CONSOLIDATED PERMIT DESIGN REVIEW and PARKING ADJUSTMENT PERMIT DECISION AND PERMIT

DR2019-0003, ADM2019-0017, SEP2019-0020

315 N. Samish Way

3 South Elevation
1/8" = 1'-0"

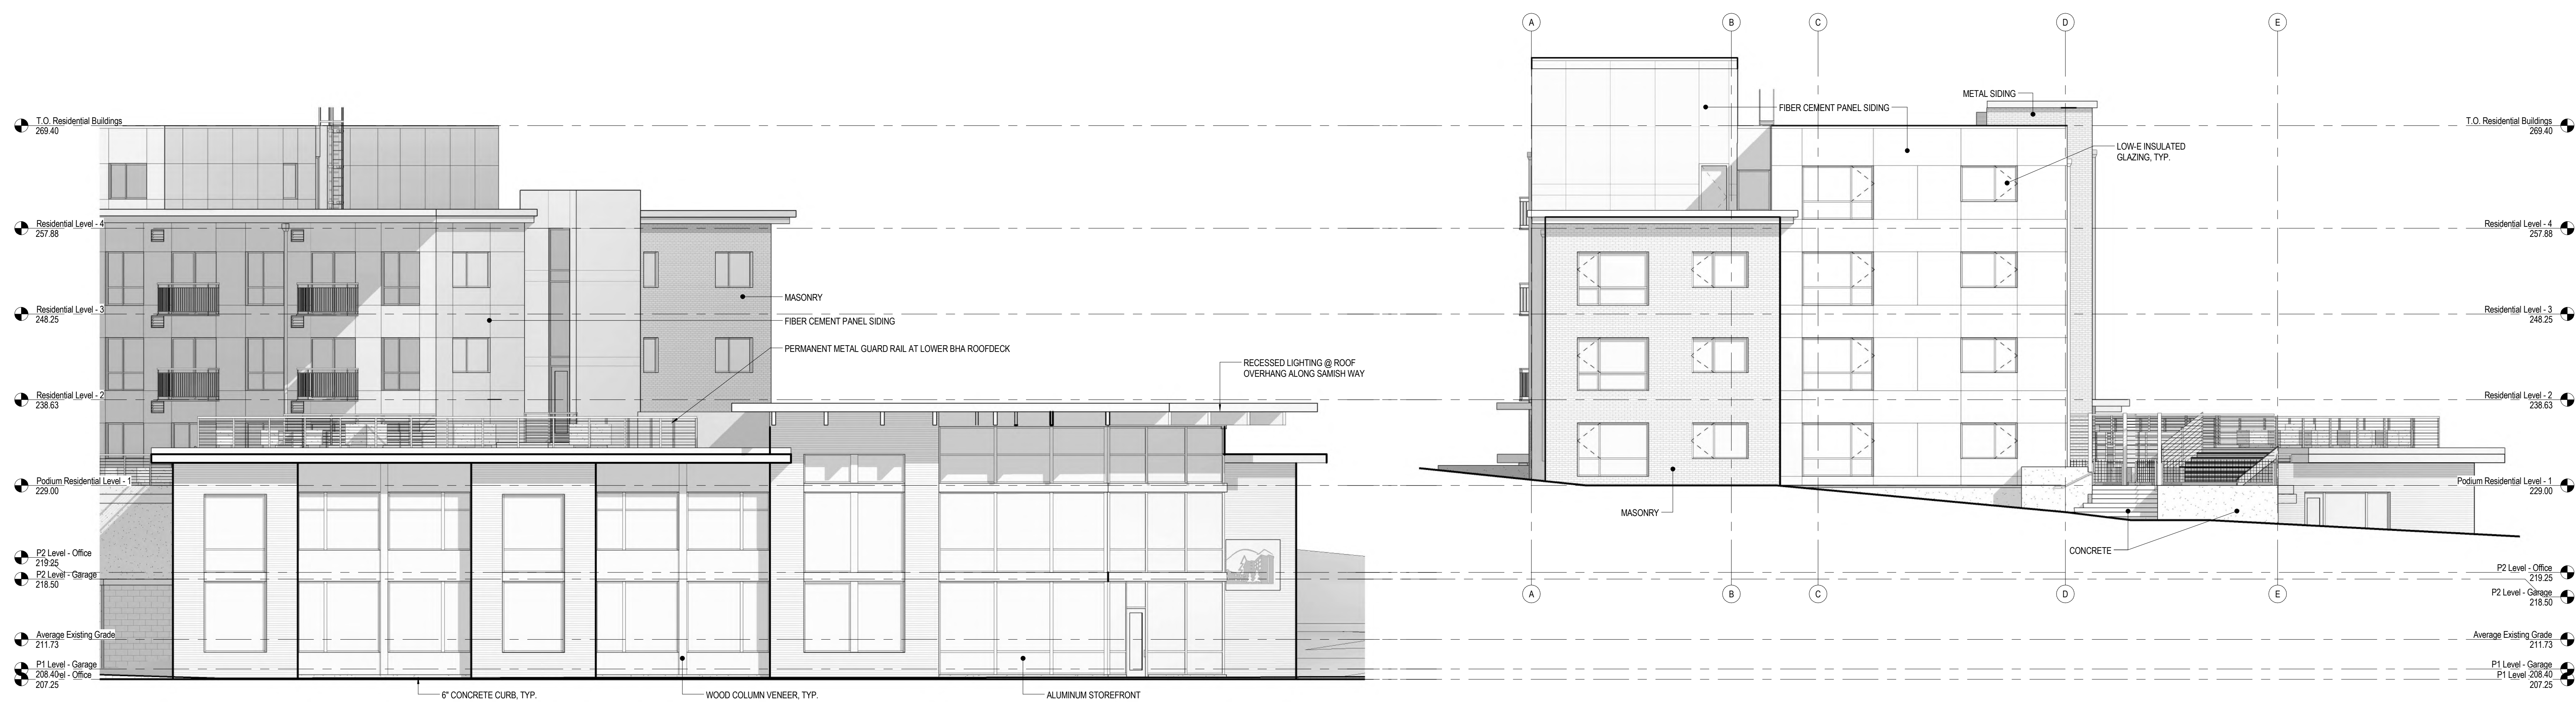
- 4) The applicant requested a design departure from (BMC 20.25.070(B)(2)(g)(ii) to allow a temporary blank wall on the 1st and 2nd floors of the south elevation perpendicular to N. Samish Way (Figure 1.2 in the DRB staff report) given the wall is temporary and will be covered when Phase 2 is constructed. The Board recommended approval of the departure since it will be temporary, and finding that the proposed interim stairs will provide sufficient visual interest to “provide an equal or better solution” to the applicable standards and fulfill the criteria in BMC 20.25.070(A)(2) for obtaining a design departure.

- b. The requested design departure in **#15(c)(4)** above (from BMC 20.25.070(B)(2)(g)(ii)) for a temporary blank wall on the 1st and 2nd floors of the south elevation perpendicular to N. Samish Way is no longer necessary. The subject elevation was modified to include openings to accommodate internal access with Phase 2 and will be filled with storefront glazing in the interim.

OTIS STREET
GRADING &
STORMWATER
PLAN
C103

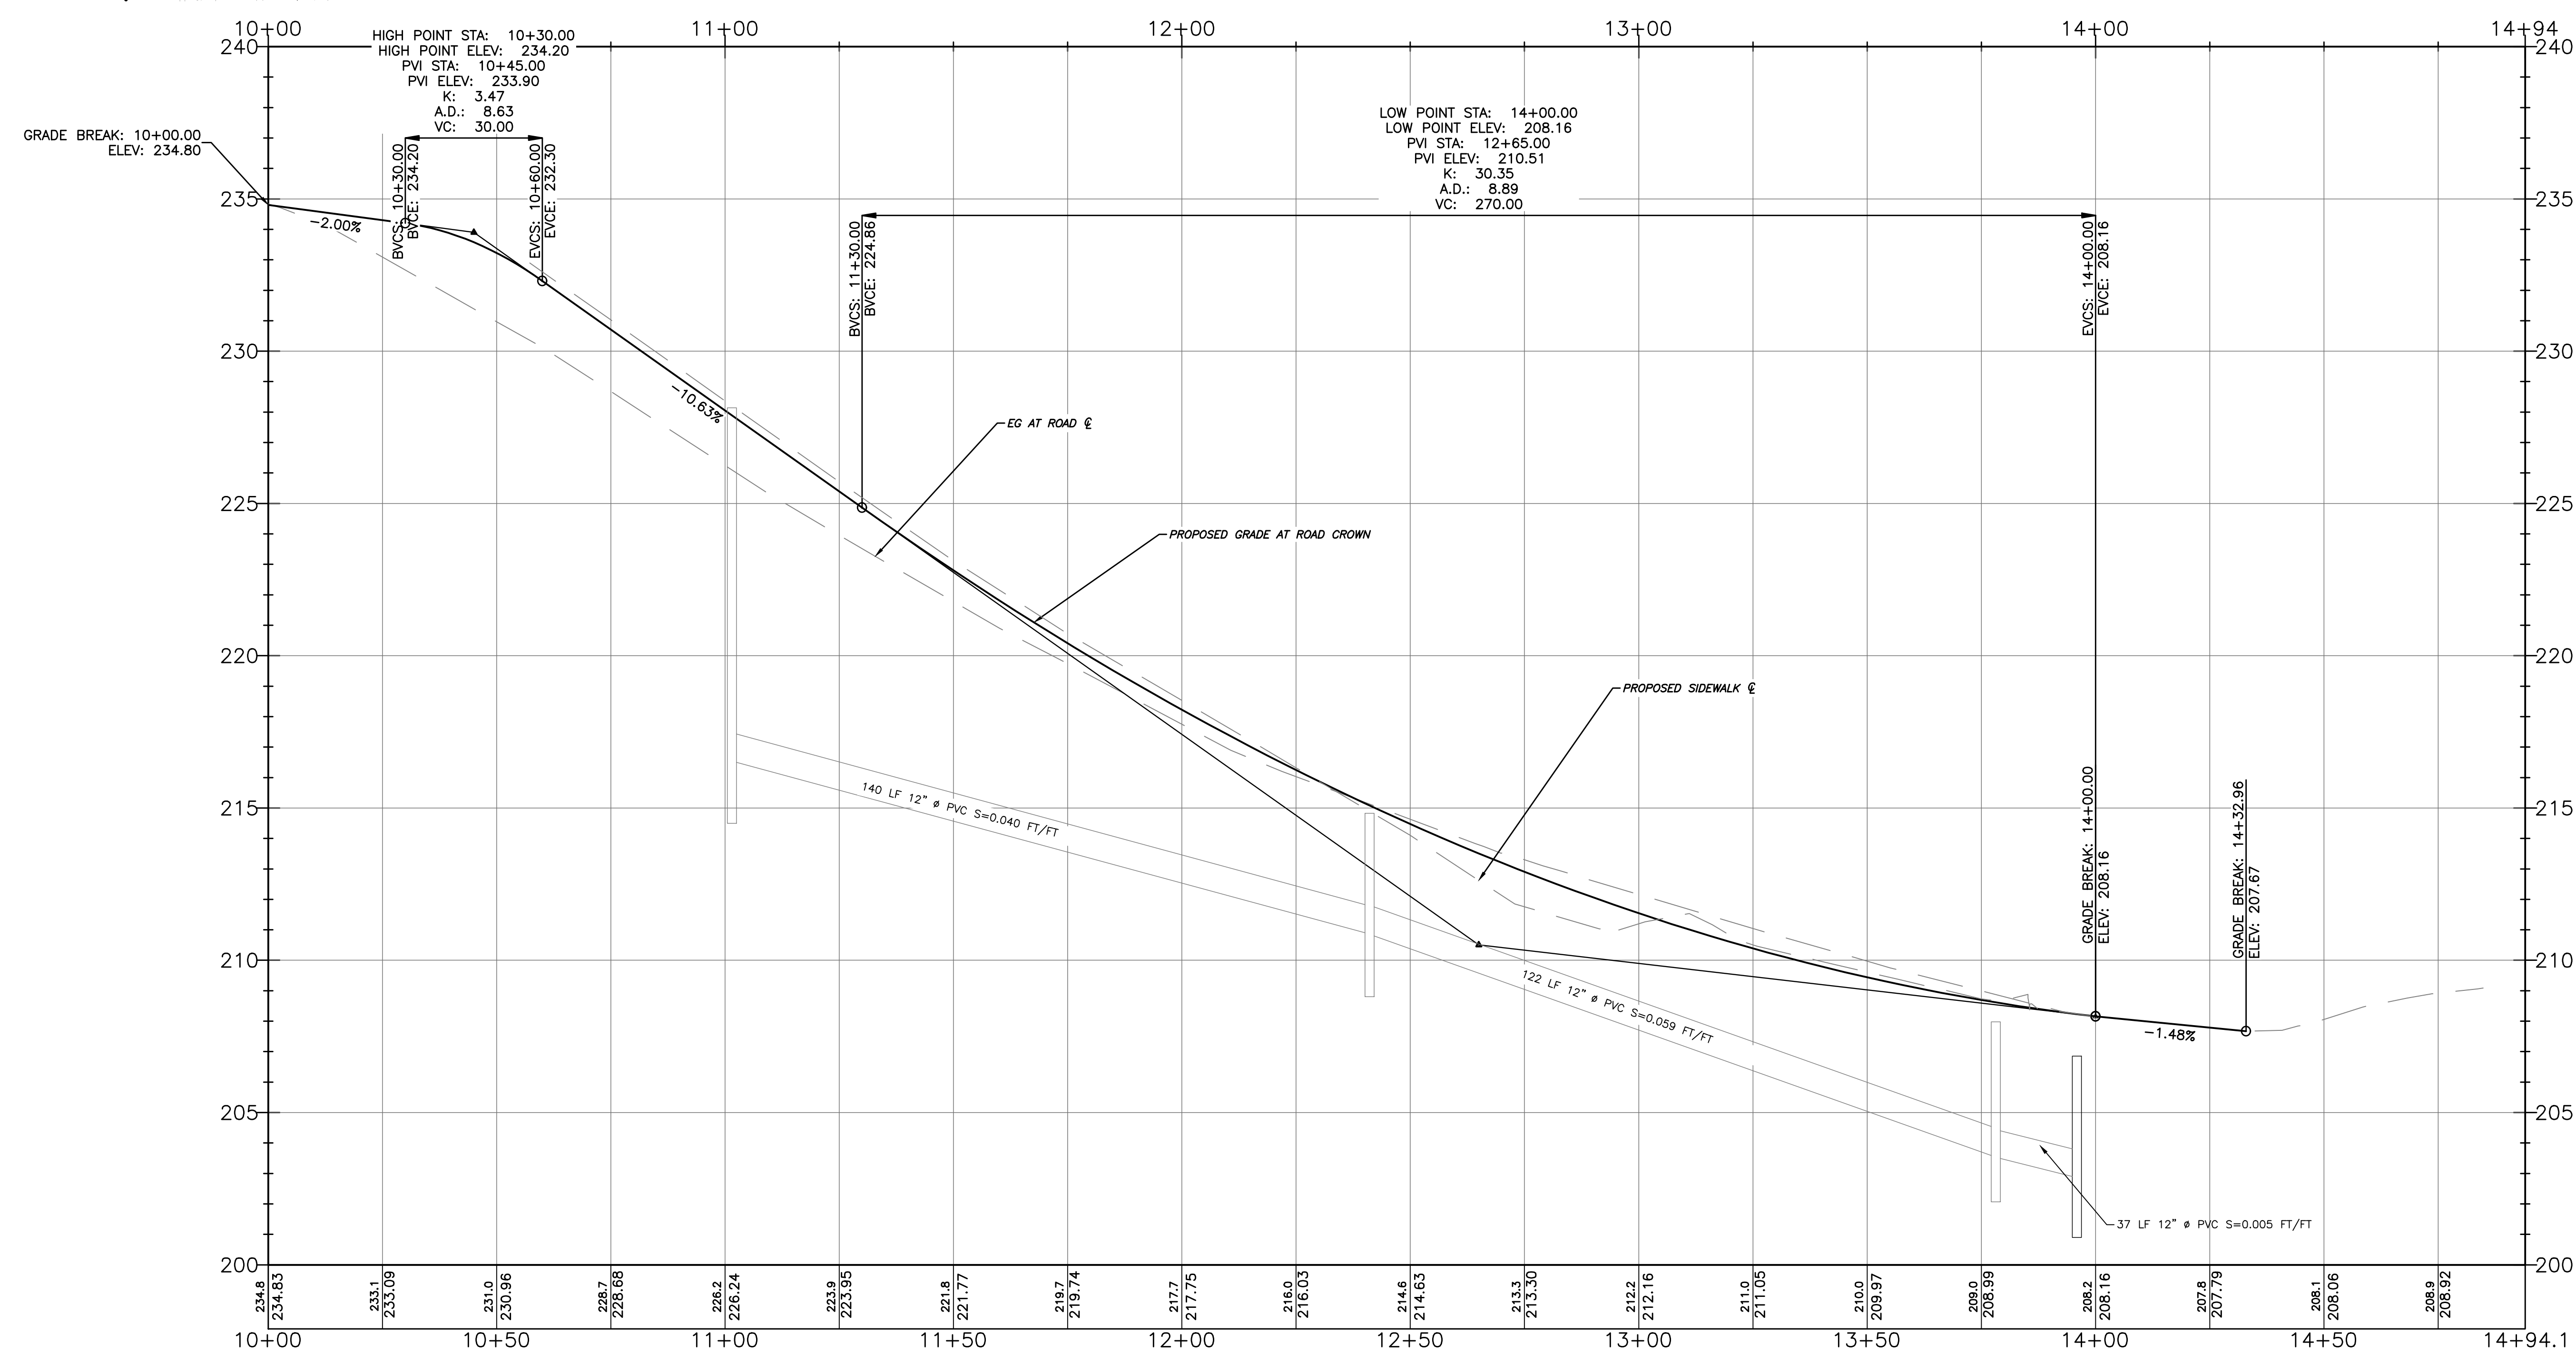
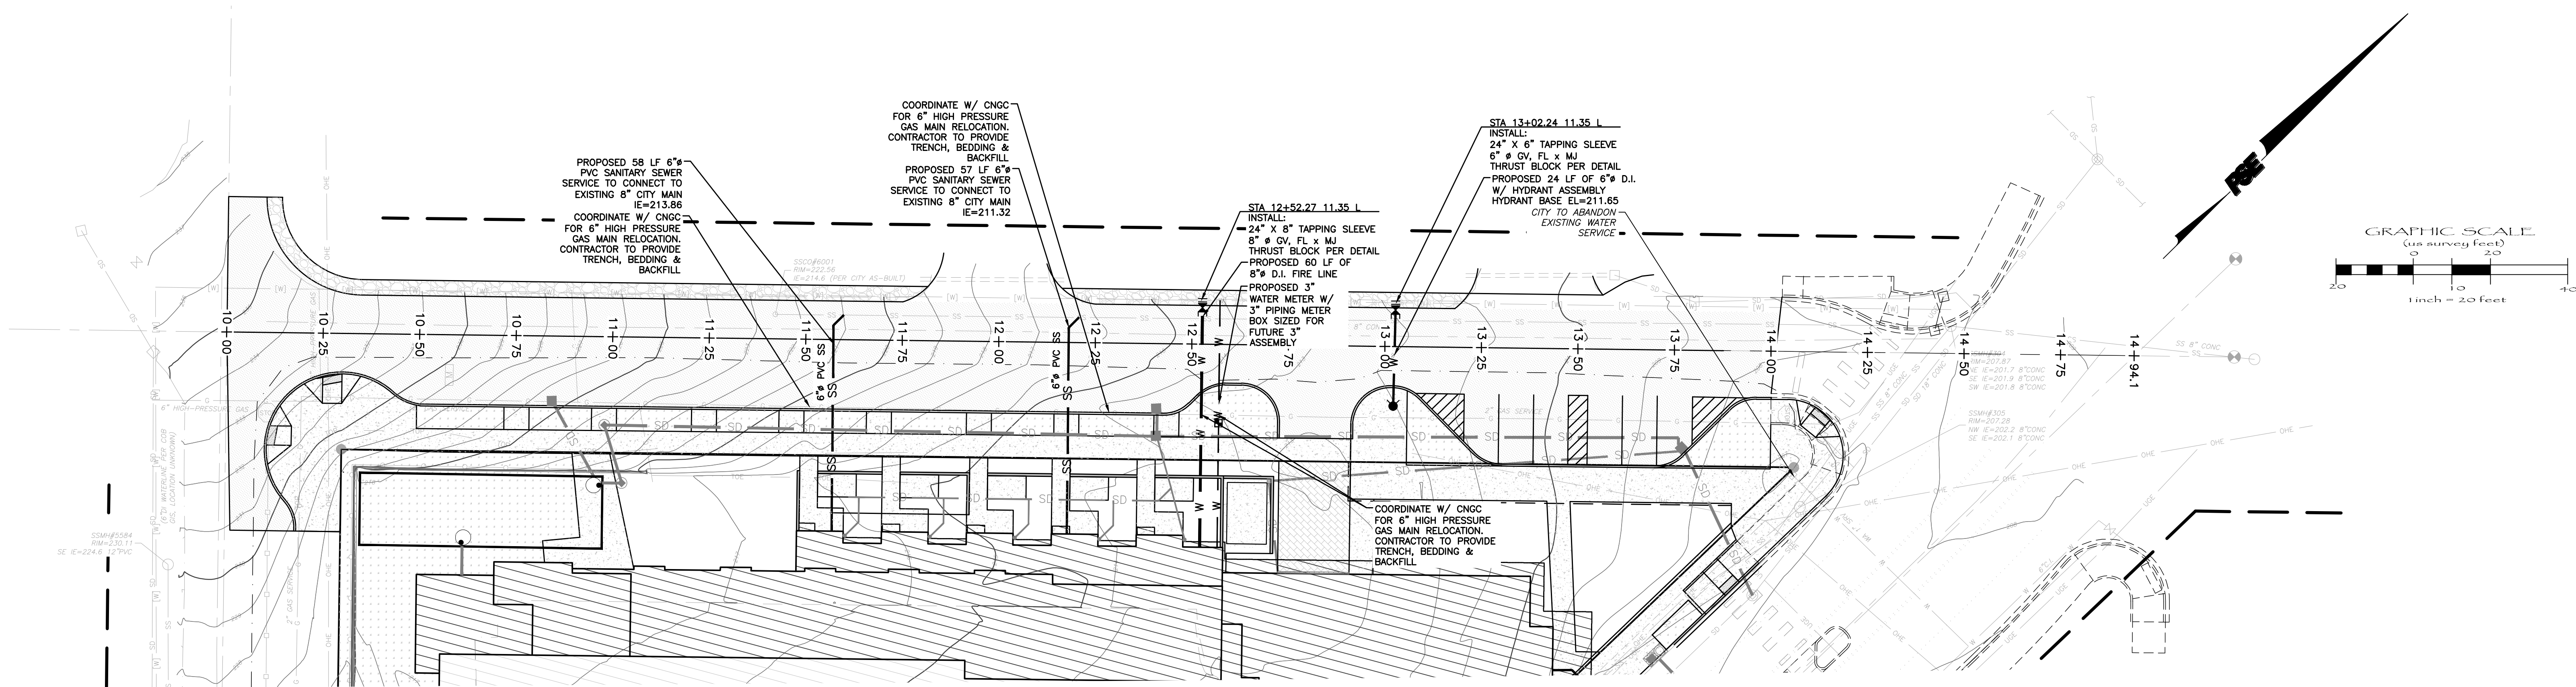
- 2) Improvements to Otis Street should be consistent with the Type II non-arterial street cross section with minor modifications as recommended in findings of fact **#21** and **22** above, including a bulbed-out intersection at Laurel Street as shown on **Exhibit C, Sheet C103**.
